Re: *Addendum No. 1*
Pierce Drive Stormwater Improvements
ABC Water & Stormwater District

Date: June 18, 2025

PIERCE DRIVE STORMWATER IMPROVEMENTS
MAHONING COUNTY BOARDMAN, OHIO
BASE BID - PROPOSED STM REPLACEMENT (1 OF 3)

PROJECT NO:	242260
DRAWING NAME	C-06
SHEET	OF
9	15

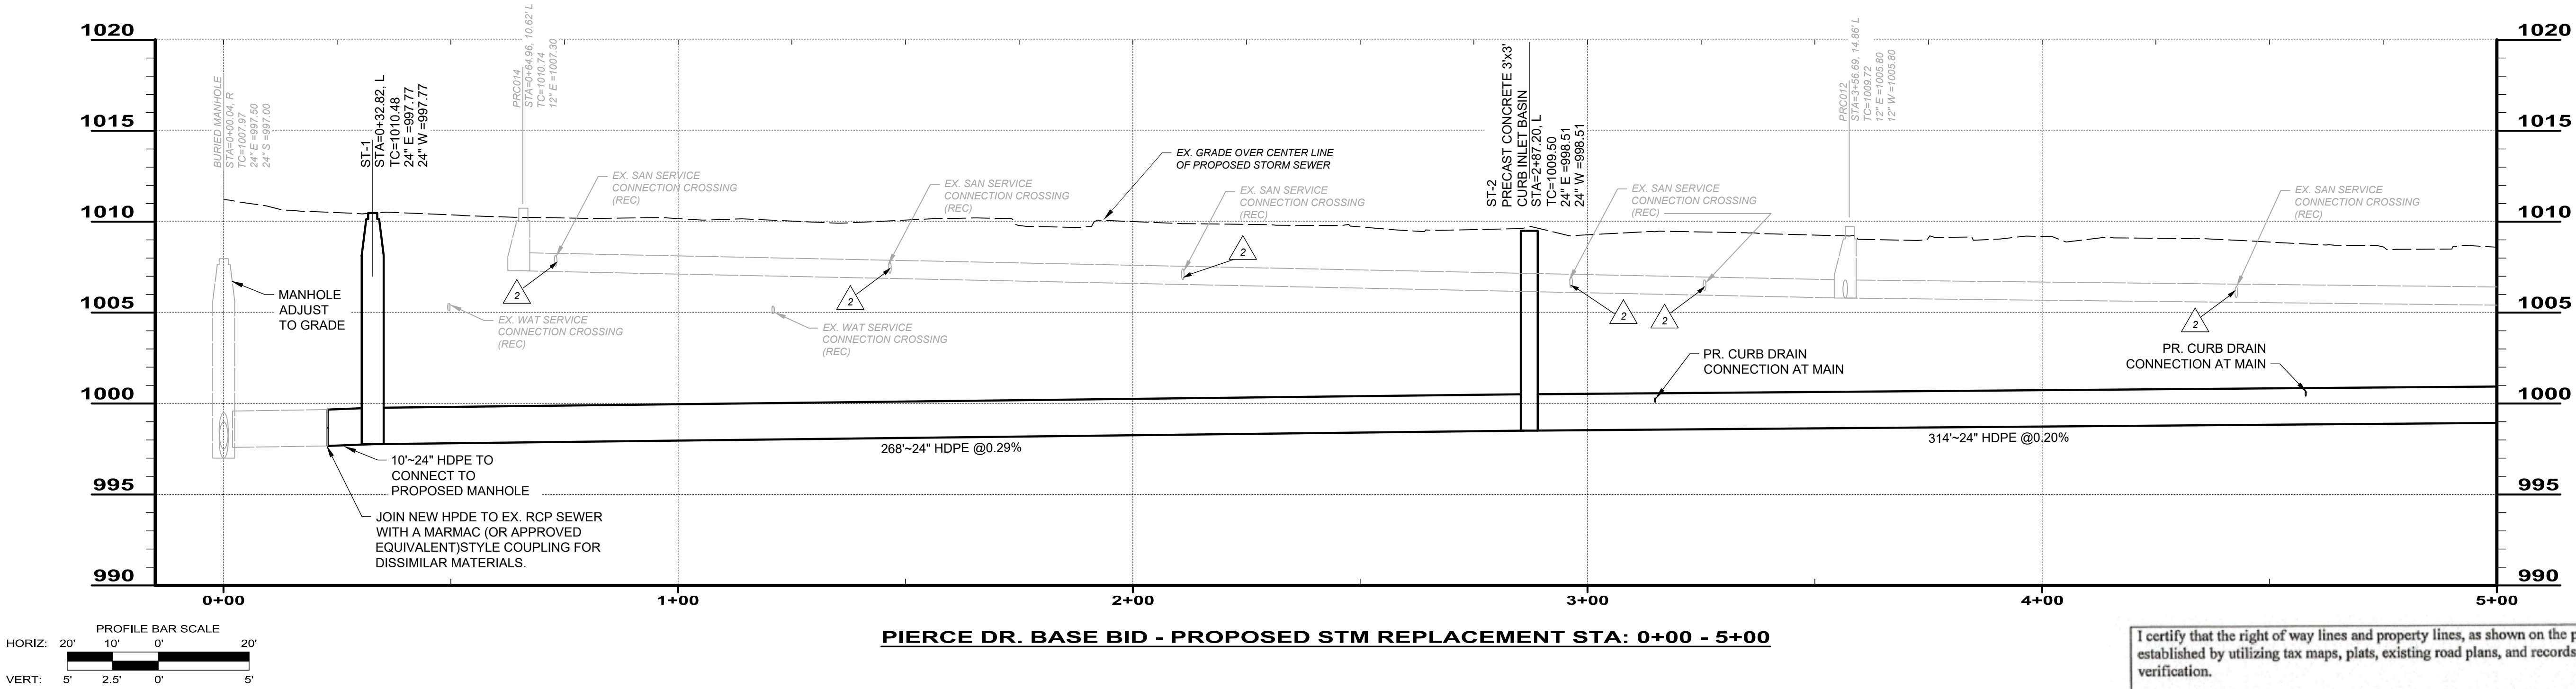
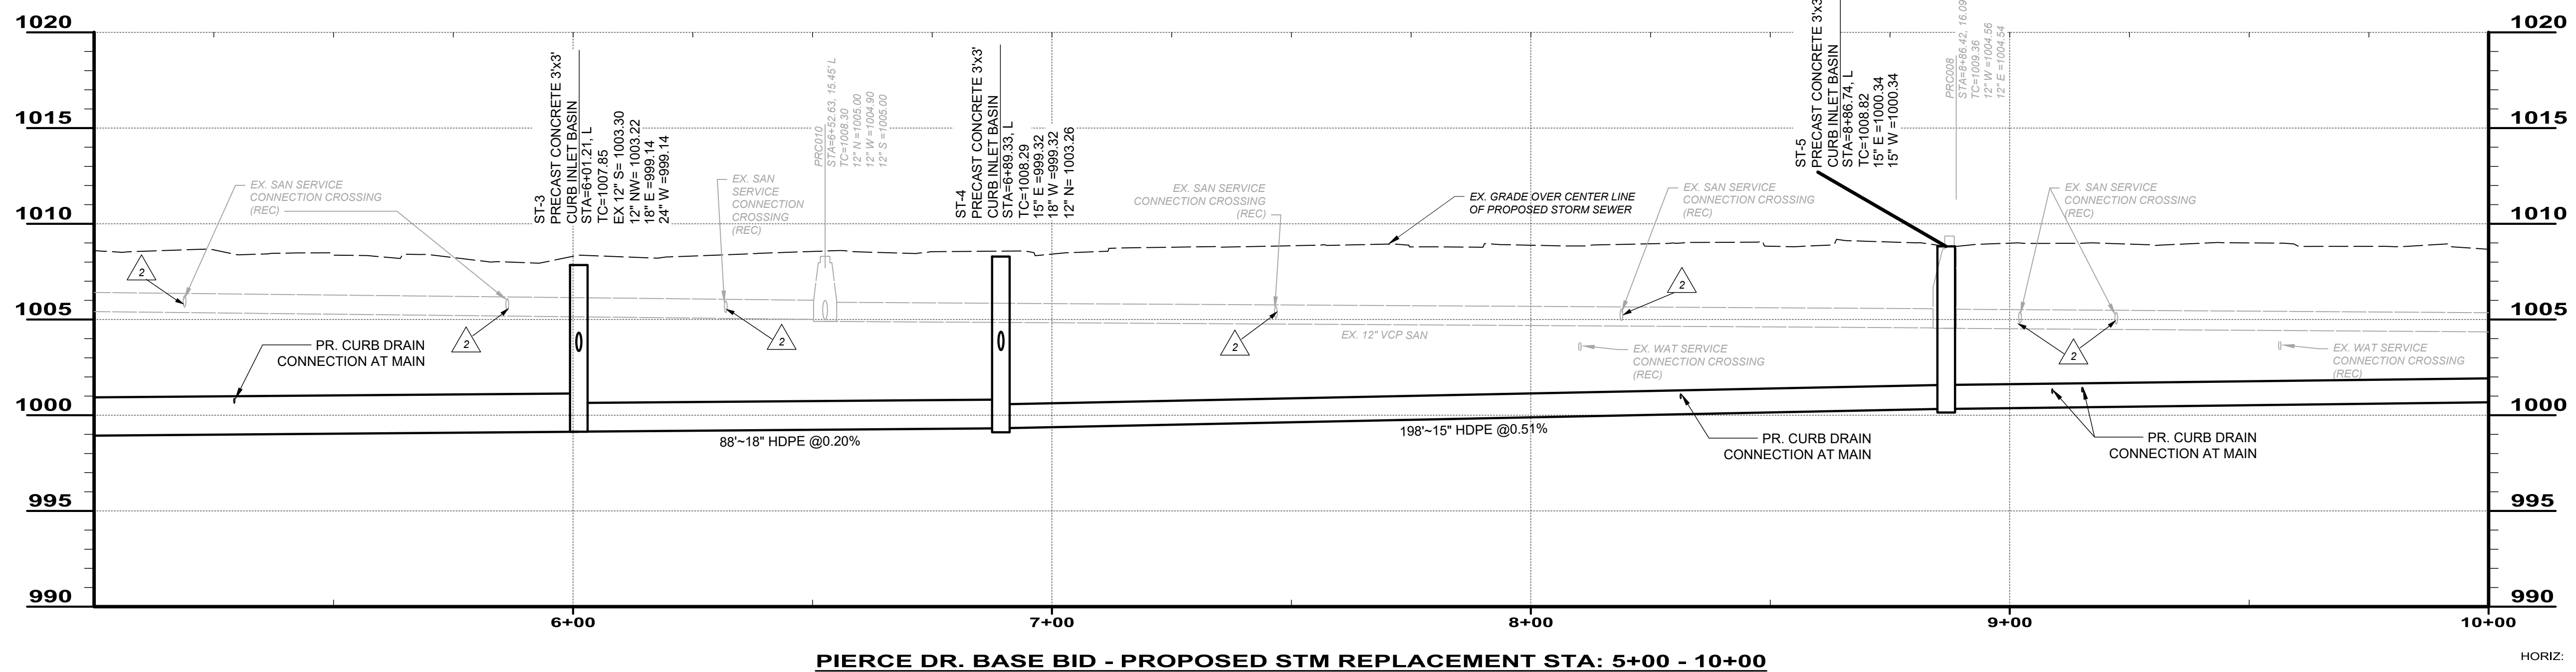
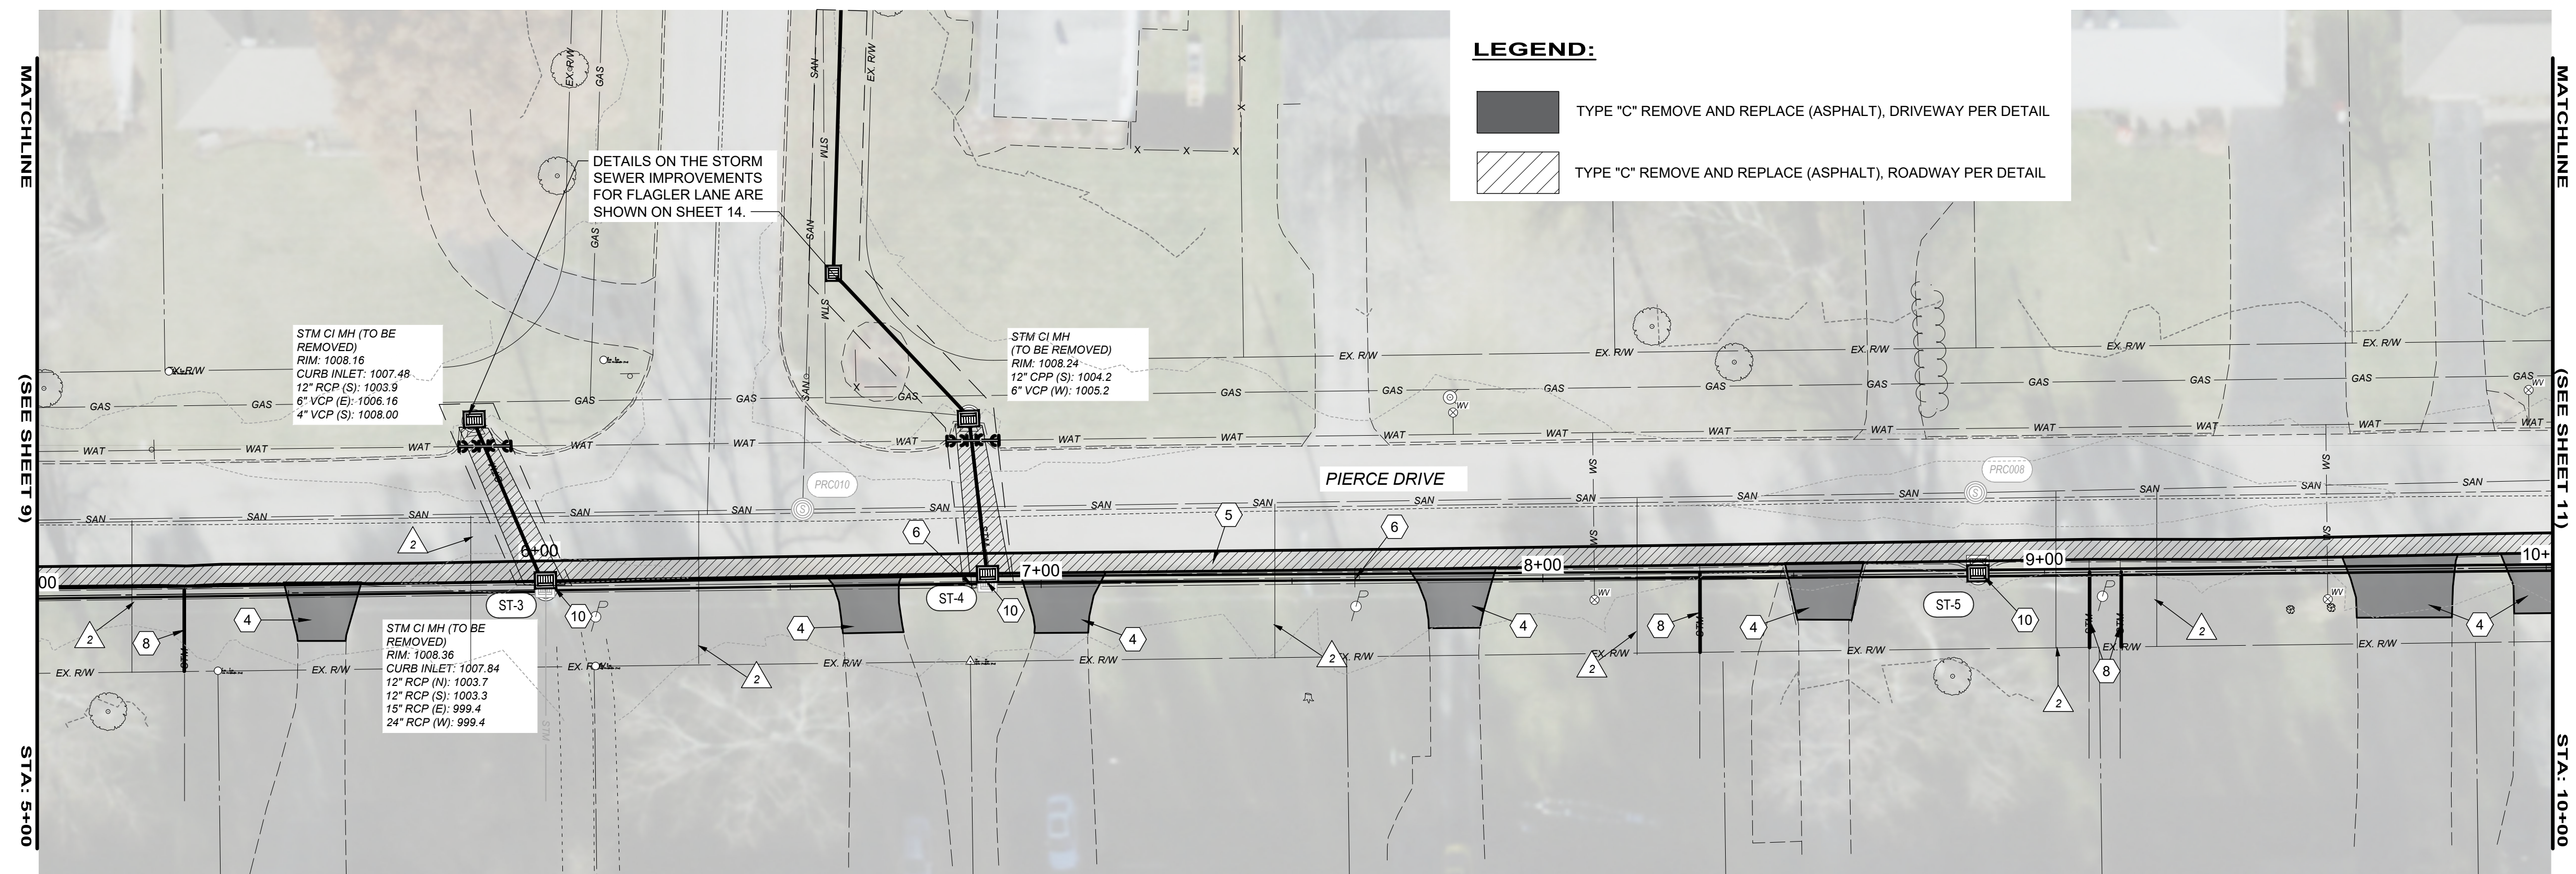
Replace plan sheets 9, 10, 11 and 14 with the enclosed Revised plan sheets 9, 10, 11 and 14.

- 1 NOT USED
- 2 CONTRACTOR SHALL CONFIRM THE LOCATIONS OF ALL SANITARY LATERAL CROSSINGS. ANY WORK CONDUCTED AROUND THE SANITARY UTILITIES SHALL BE SUPPORTED PROPERLY DURING CONSTRUCTION. MCSE SHALL BE NOTIFIED IF ANY DAMAGE IS INCURRED TO THE SANITARY UTILITIES DURING CONSTRUCTION AND SHALL BE AT THE COST OF THE CONTRACTOR. REPAIRS SHALL BE MADE ACCORDING TO THE STANDARDS SET BY MCSE.
